# Work Order ID 91765

Item Name: Crosstube Turning Detail

<b>DART AEROSPACE LTD</b>	<b>Work Order:</b>	<b>91765</b>
<b>Description:</b> Crosstube Assembly (412 High Aft)	<b>Part Number:</b>	<b>D412-664-243</b>
<b>Inspection Dwg:</b> D412-664-243 <b>Rev:</b> E		<b>Page 1 of 2</b>

DRAWING NO. D412-664-243	TITLE CROSSTUBE ASSEMBLY (412 HI AFT)	REV. E	DART AEROSPACE LTD ENGINEERING ORDER		D.E.O. NO. D412-664-243-E-1	SHEET NO. SHEET 1 OF 2	SCALE NTS
DRAWN	CHECKED	MFG. APPR.	APPROVED	DE APPR.			
DATE 11.03.31	DATE 11/03/31	DATE 11.03.31	DATE 11/03/31	DATE 11-03-31

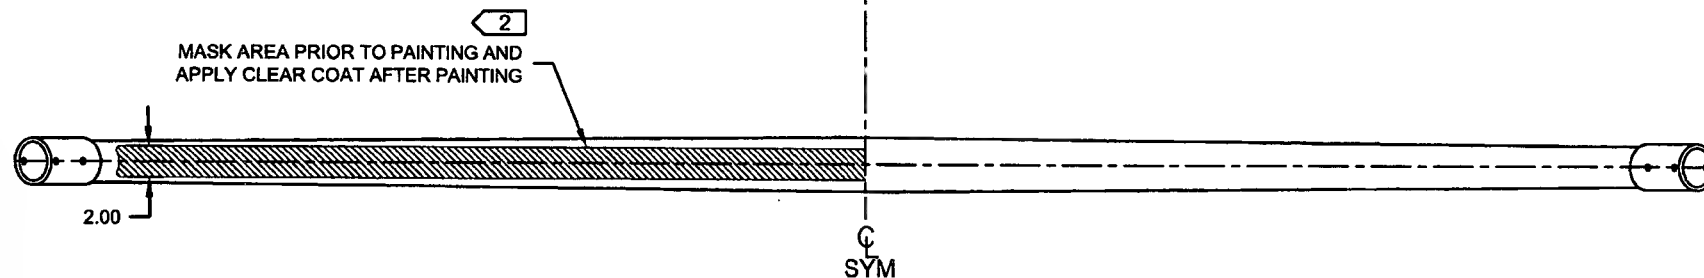
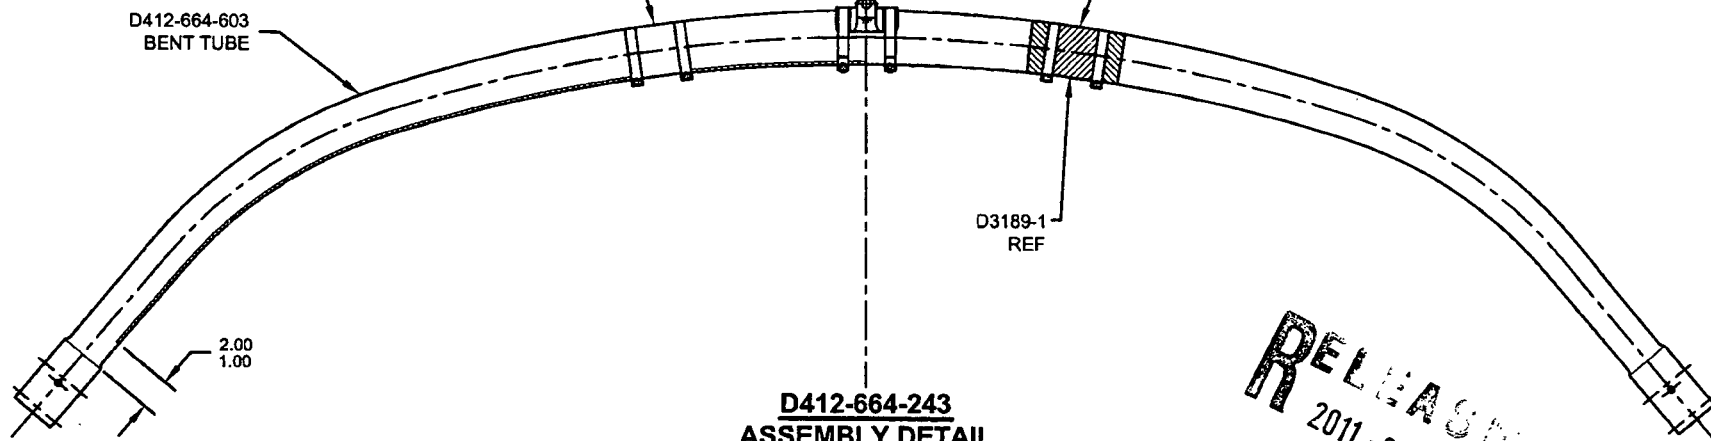
**PURPOSE:**

REMOVED ABRASION STRIP IN FAVOR OF A THIN LAYER OF PROSEAL 890.

**CHANGE:**

PARTS LIST IS AMENDED AS FOLLOWS:

**IS:**

Item	Qty -243	Part Number	Description
6	0	D2856-600-1009	ABRASION STRIP

**WAS:**

6	2	D2856-600-1009	ABRASION STRIP
---	---	----------------	----------------

NOTES 2 AND 14, SHEET 1 ARE AMENDED AS FOLLOWS:

**IS:**

- 2) FINISH: CHEMICAL CONVERSION COAT PER DART QSI 005 4.1  
PRIME INSIDE AND OUTSIDE PER DART QSI 005 4.2  
MASK UNDERSIDE OF CROSSTUBE AS SHOWN (HATCHED AREA)  
PAINT OUTSIDE PER DART QSI 005 4.2  
AFTER PAINTING, APPLY CLEAR COAT ON HATCHED AREA
- 14) APPLY A THIN COAT OF PROSEAL 890 ON INSIDE CONCAVE SURFACE OF D3189-1  
CHAFING SHIELD AND LET CURE PER MANUFACTURER'S INSTRUCTIONS. INSTALL  
PROSEALED D3189-1 CHAFING SHIELD ONTO CROSSTUBE BY APPLYING A THIN COAT OF  
PROSEAL 890 ONTO CROSSTUBE. BE SURE TO ELIMINATE ANY AIR GAPS.

**WAS:**

- 2) FINISH: CHEMICAL CONVERSION COAT PER DART QSI 005 4.1  
PRIME INSIDE AND OUTSIDE PER DART QSI 005 4.2  
PAINT OUTSIDE PER DART QSI 005 4.2
- 14) INSTALL D2856-600-1009 ABRASION STRIPS WITH A 0.13 REF GAP ON BOTTOM SIDE OF  
CROSSTUBE PER QSI 035.

**IS:**

D3189-1 CHAFING SHIELD (1, INSTALLED OVER PROSEAL 890)  
MS21920-28 CLAMP, 2X  
2 PL

**WAS:**

D2856-600-1009 ABRASION STRIP  
D3189-1 CHAFING SHIELD (1, INSTALLED OVER ABRASION STRIP)  
MS21920-28 CLAMP, 2X  
2 PL

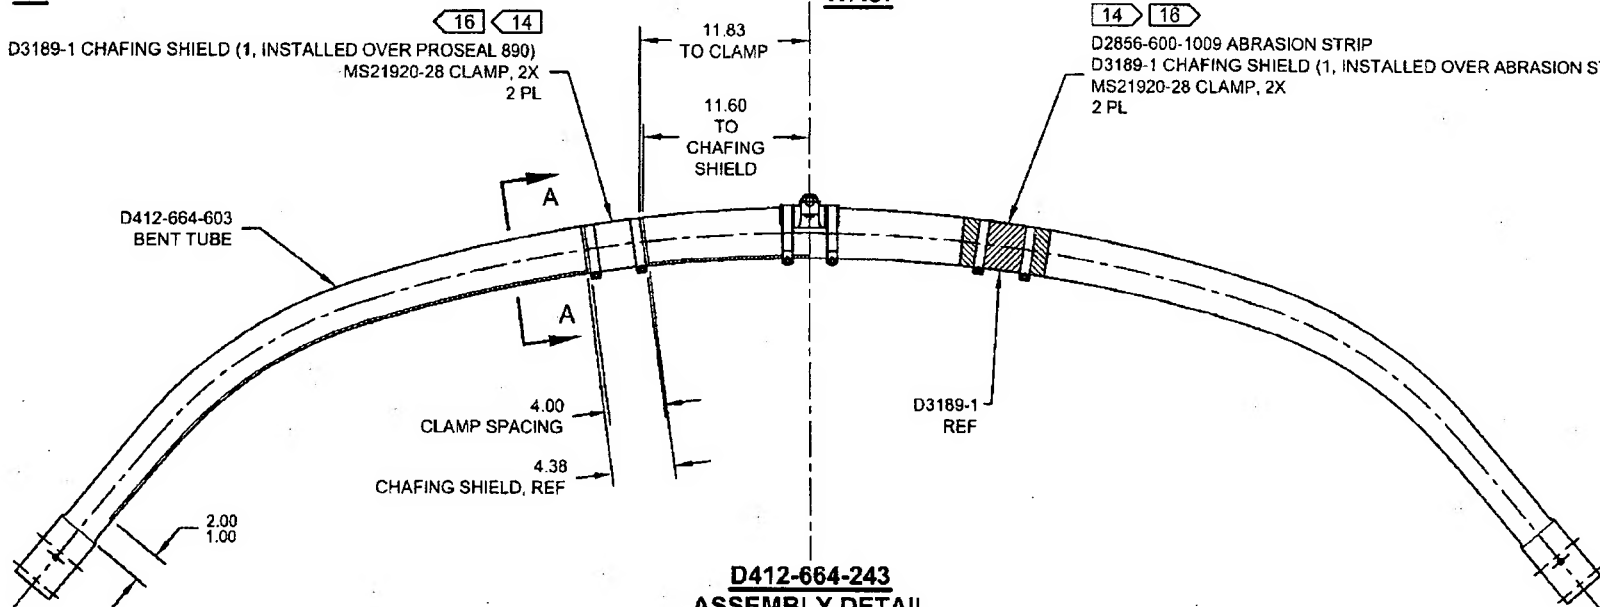
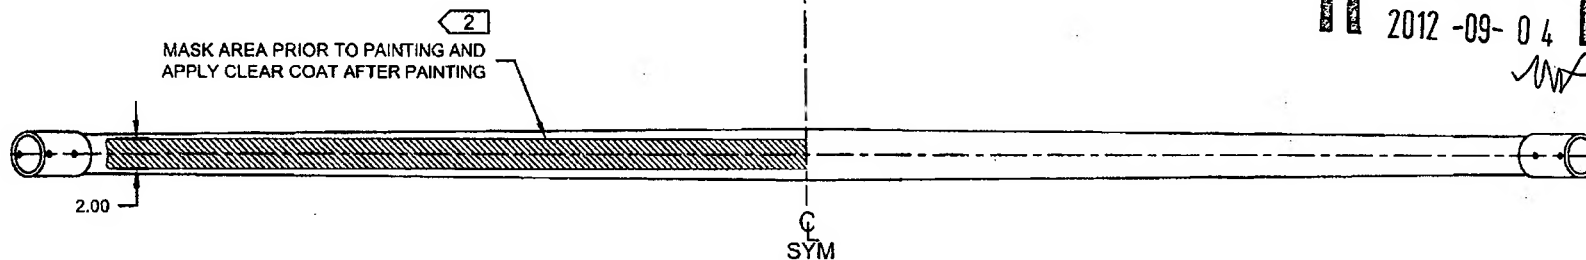
**PURPOSE:**

REMOVED ABRASION STRIP IN FAVOR OF A THIN LAYER OF PROSEAL 890. UPDATE INSTALLATION OF CHAFING SHIELDS AND REDUCE TORQUE TO 40-50 IN-LBS. THIS ENGINEERING ORDER SUPERCEDES DEO D412-664-243-E-1.

**CHANGE:**

PARTS LIST IS AMENDED AS FOLLOWS:

**IS:**

Item	Qty -243	Part Number	Description
6	0	D2856-600-1009	ABRASION STRIP

**WAS:**

6	2	D2856-600-1009	ABRASION STRIP
---	---	----------------	----------------

NOTES 2, 14, AND 16 ON SHEET 1 ARE AMENDED AS FOLLOWS:

**IS:**

- 2) FINISH: CHEMICAL CONVERSION COAT PER DART QSI 005 4.1  
PRIME INSIDE AND OUTSIDE PER DART QSI 005 4.2  
MASK UNDERSIDE OF CROSSTUBE AS SHOWN (HATCHED AREA)  
PAINT OUTSIDE PER DART QSI 005 4.2  
AFTER PAINTING, APPLY CLEAR COAT ON HATCHED AREA
- 14) APPLY A THIN COAT OF PROSEAL 890 ON INSIDE CONCAVE SURFACE OF D3189-1 CHAFING SHIELD AND LET CURE PER MANUFACTURER'S INSTRUCTIONS. INSTALL PROSEALED D3189-1 CHAFING SHIELD ONTO CROSSTUBE BY APPLYING A THIN COAT OF PROSEAL 890 ONTO CROSSTUBE. BE SURE TO ELIMINATE ANY AIR GAPS.
- 16) TORQUE CLAMPS ON D2896-1 SUPPORT 80 TO 100 IN-LB. **TORQUE CLAMPS ON D3189-1 CHAFING SHIELD 40 TO 50 IN-LB.** ENSURE AT LEAST 1.5 THREADS SHOWING IN SAFETY AND THAT NUT HAS NOT BOTTOMED-OUT AFTER TORQUING.

**WAS:**

- 2) FINISH: CHEMICAL CONVERSION COAT PER DART QSI 005 4.1  
PRIME INSIDE AND OUTSIDE PER DART QSI 005 4.2  
PAINT OUTSIDE PER DART QSI 005 4.2
- 14) INSTALL D2856-600-1009 ABRASION STRIPS WITH A 0.13 REF GAP ON BOTTOM SIDE OF CROSSTUBE PER QSI 035.
- 16) TORQUE CLAMPS 80 TO 100 IN-LB. ENSURE AT LEAST 1.5 THREADS SHOWING IN SAFETY AND THAT NUT HAS NOT BOTTOMED-OUT AFTER TORQUING.

**IS:**

D3189-1 CHAFING SHIELD (1, INSTALLED OVER PROSEAL 890)  
MS21920-28 CLAMP, 2X  
2 PL

D412-664-603  
BENT TUBE

**WAS:**

D2856-600-1009 ABRASION STRIP  
D3189-1 CHAFING SHIELD (1, INSTALLED OVER ABRASION STRIP)  
MS21920-28 CLAMP, 2X  
2 PL

MASK AREA PRIOR TO PAINTING AND  
APPLY CLEAR COAT AFTER PAINTING
